Re: **Review of the Report of Leachate Monitoring and Recommended Changes to the ELGE Remedy**
Operable Unit 1 – Keystone Sanitation Landfill Superfund Site, Union Twp., Adams Co., PA

**Subject: Technical Review of Golder Associates, Inc. and HydroGeoLogic, Inc.
April 2018 Report Leachate Monitoring Results and Recommended Changes
to the ELGE Remedy**

Figure 1
Estimated Landfill Gas Extraction Coverage at South Portion of Landfill

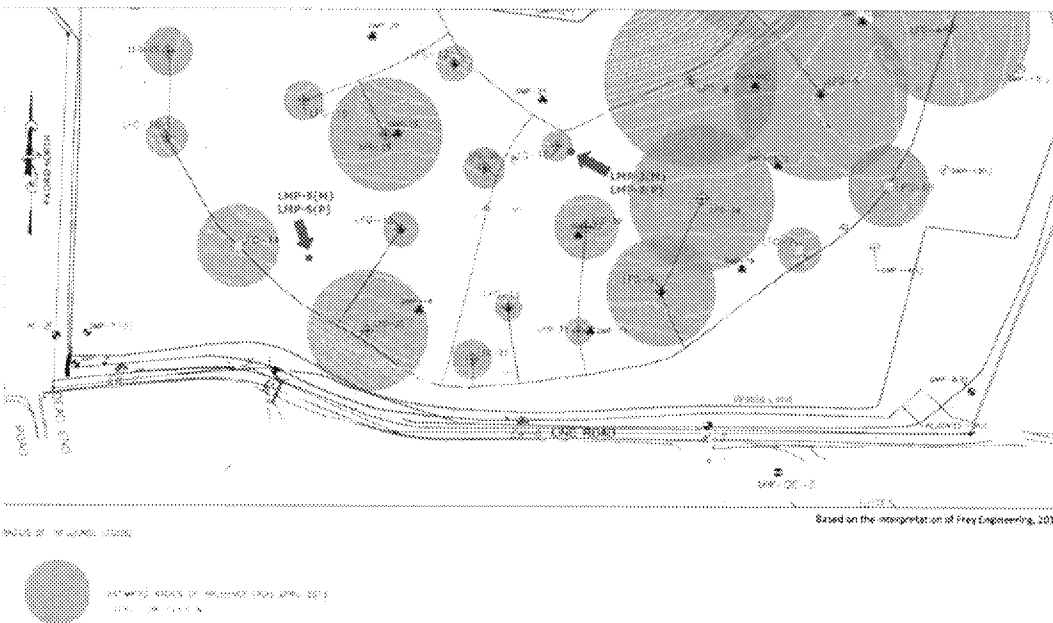
The high concentration of 1,4 dioxane in both the leachate and in groundwater at the LMP-5 couplet may, in part, be explained by the lack of influence from the Gas Extraction System Radius of Influence, and the lower vapor pressure of 1,4-dioxane. Based on 2014 Frey Engineering work, attached is an overlay of the approximated Radius of Influences (ROIs) of gas extraction points relative to the two new leachate monitoring points containing landfill leachate (Figure 1). As shown, the ROI of the current gas

extraction system does not reach the location of the LMP-5 couplet, and barely reaches the LMP-3 couplet. This figure demonstrates that the existing gas collection system is *not* reaching some areas of the landfill where leachate is now known to exist. This also happens to be the area beneath which the most persistent, and highest concentration chemicals remain in groundwater.

We recommend that the additional investigation be focused on better defining leachate locations, understanding leachate chemistry, and improving the ROI coverage of the ELGE/landfill gas recovery system.

FIGURE 2
LEACHATE MONITORING POINTS
 (LOCATION INDEPENDENT)

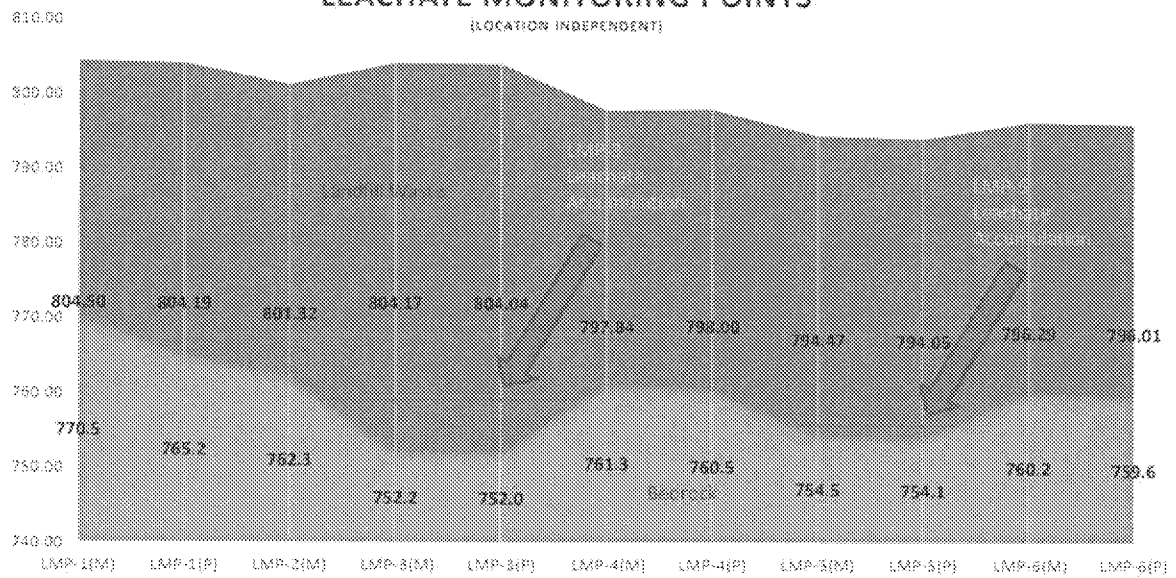
that are within 300 to 400 feet of one another. A groundwater gradient of 0.1 is very unlikely in these situations and Golder-LHG should explore the cause of these differences. The relationship between leachate accumulation and depth becomes very clear when illustrated as in Figure 2, attached.

Both LMP-1(M) and, LMP-2(M) have a screen elevation well above the leachate encountered in LMP-3(M) and LMP-5(M). LMP-1(M) and, LMP-2(M) are historically reported by Golder to be "dry" of leachate and may be so because (1) they were installed well-above an elevation where leachate is generated and accumulates or (2) they "missed" the perched leachate exists because the leachate pockets in certain areas are of limited areal extent. Either explanation is consistent with the revised conceptual model. Leachate monitoring points LMP-3(M) and LMP5(M) are installed at elevations below the other leachate monitoring points, suggesting that the leachate at the landfill favors those areas of the waste mass where the waste is at its deepest.
